Nant Mithil Energy Park, Powys.  
PEDW DNS Application Ref: DNS CAS-01907-D7Q6Z1.

CPRW-ReThink Chapter 19 on

## **Summary of Interrelated Cumulative Effects and Likely Significant Effects**

Prepared by: Dr Christine Hugh-Jones (CPRW) and Jenny Chryss (RE-think)

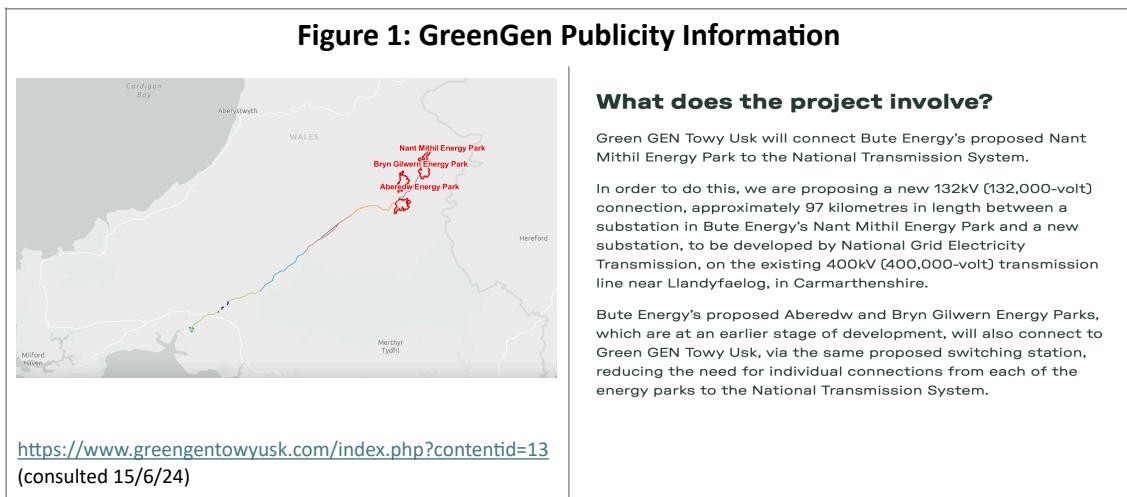
- 4.5. Bute left no doubt that these projects were intrinsically related and would come forward as shown in publicity by GGC. GGC had been established as a separate company under Windward Energy to handle the necessary grid infrastructure for Bute's wind farm projects (figure 1).

**Figure 2. VP21 from Castle Bank**

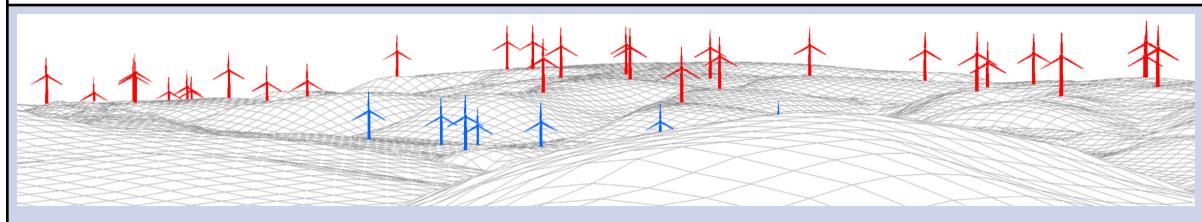
7.3. The view from Castle Bank illustrates the effect of scoping out other Bute projects close behind Nant Mithil in development terms (figure 2). It shows the seven partially obscured Hendy turbines with all thirty Nant Mithil turbines which are more distant but double the size and in some cases appear larger. The cumulative assessment mistakenly says no other consented (Scenario A) or proposed (Scenario B) wind energy developments will be evident. We cannot explain this statement because the seven inoperative Hendy turbines are obviously a source of cumulative effects and are shown in Fig 5.20. (they are also omitted for a number of other Scenario B assessments of view-points from which they are visible). The "primary assessment" impact is only assessed as "Moderate" because views in other directions are available and the view of two wind farms will "*will visually extend the effect of the Proposed Development*

*from the upland slopes of Radnor Forest into the valley below across topographical boundaries".*

**Figure 3: View points for Aberedw Hill (PAC ES).**

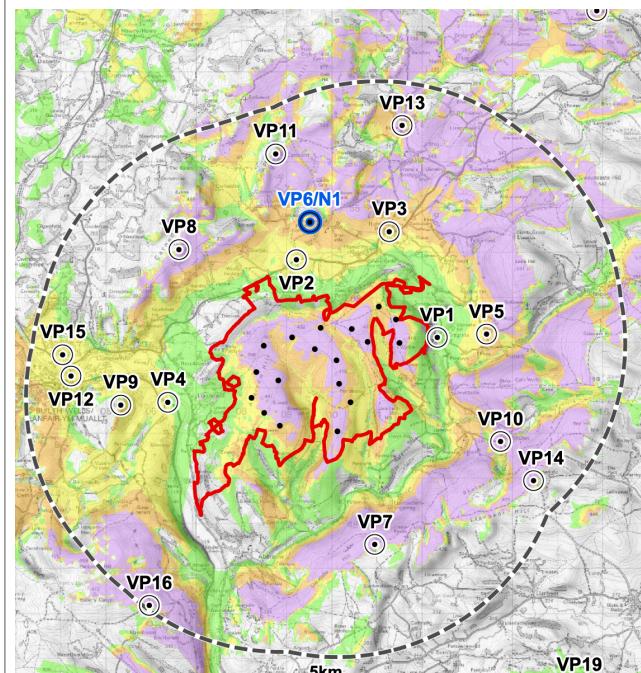
7.4. Although Aberedw EP is scoped out, we can see the effect of adding it in because Castle Bank appears as VP11 in the Aberedw EP PAC ES (figure 3).

**Figure 4: View of Aberedw Hill to the South from Castle Bank VP11 (PAC ES) with Photomontage**

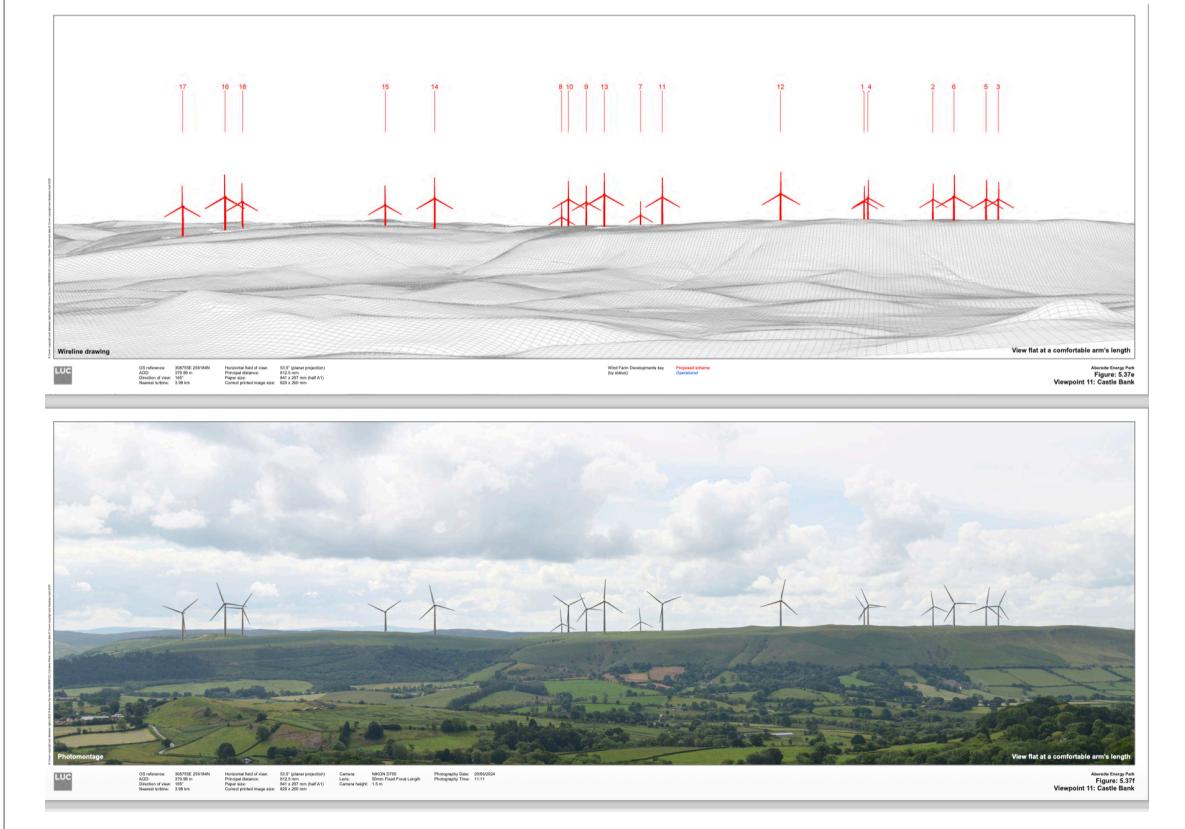
There is no photomontage in the Nant Mithil ES treatment of Castle Bank and we think one should have been supplied. The AH.VP11.photo montage suggests just how unlikely it is that the viewer of Hendy combined with Nant Mithil, each with different size turbines in such different topographical settings, would be fooled into “perceiving” these as one development and not two adjacent heterogenous developments underlining the uncontrolled proliferation of development in a rural setting.
